Access Compliance Report

Intersection ID: 47832	Main Street: TOM_SHORT_RD	Cross Street: CAMP_VERDE_LN	Location: NW
ADA ID: 2BBD9FB27EEF	Ramp Type: BlendTrans1	Initial Pass/Fail: Fail	Overall Compliance: No
		Severity Score: 8.75

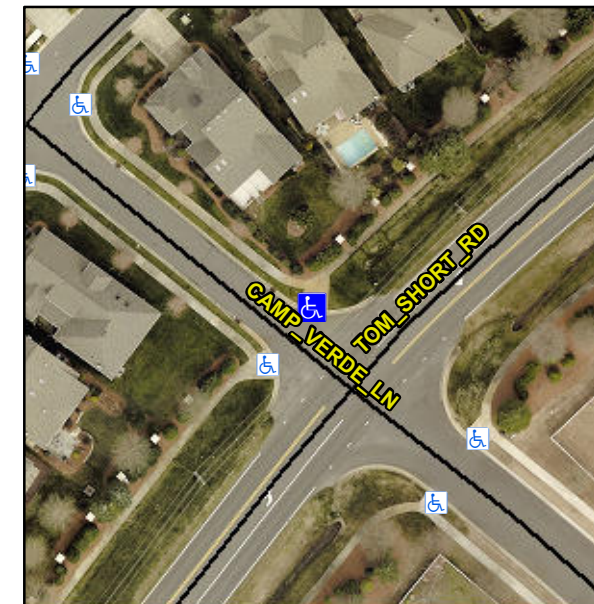
R304.5.1

Compliance	Description	Data	Compliance	Description	Data
N/A	Ramp Length (in)	74.0	Yes	BlendTrans Slope (%)	2.2
No	Ramp Width (in)	46.5	Yes	BlendTrans XSlope (%)	1.0
N/A	Flare Type LT	N/A	N/A	Flare Type RT	N/A
N/A	Flare Slope LT (%)	N/A	N/A	Flare Slope RT (%)	N/A
N/A	Flare Traversable LT?	N/A	N/A	Flare Traversable RT?	N/A
N/A	Landing Length (in)	N/A	N/A	DWS Provided?	N/A
N/A	Landing Width (in)	N/A	N/A	DWS Contrast?	N/A
N/A	Landing Slope (%)	N/A	N/A	DWS Length (in)	N/A
N/A	Landing X Slope (%)	N/A	N/A	DWS Full Width?	N/A
N/A	Landing Curb? (Y/N)	N/A	N/A	DWS Offset (in)	N/A
N/A	Shared Landing?	N/A			
N/A	Gutter Ponding?	N/A	N/A	Gutter Slope (%)	N/A
N/A	Gutter Lip Ht (in)	N/A	N/A	Gutter X Slope (%)	N/A
N/A	Painted X Walk1?	No	N/A	Painted X Walk2?	No
	X Walk 1 Direction	To SW		X Walk 2 Direction	To SE
	X Walk 1 Width (in)	N/A		X Walk 2 Width (in)	N/A
	X Walk 1 Slope (%)	1.8		X Walk 2 Slope (%)	0.9
	X Walk 1 X Slope (%)	0.2		X Walk 2 X Slope (%)	0.1

Remove & Replace Curb Ramp With Two New Directional Ramps or Equivalent.
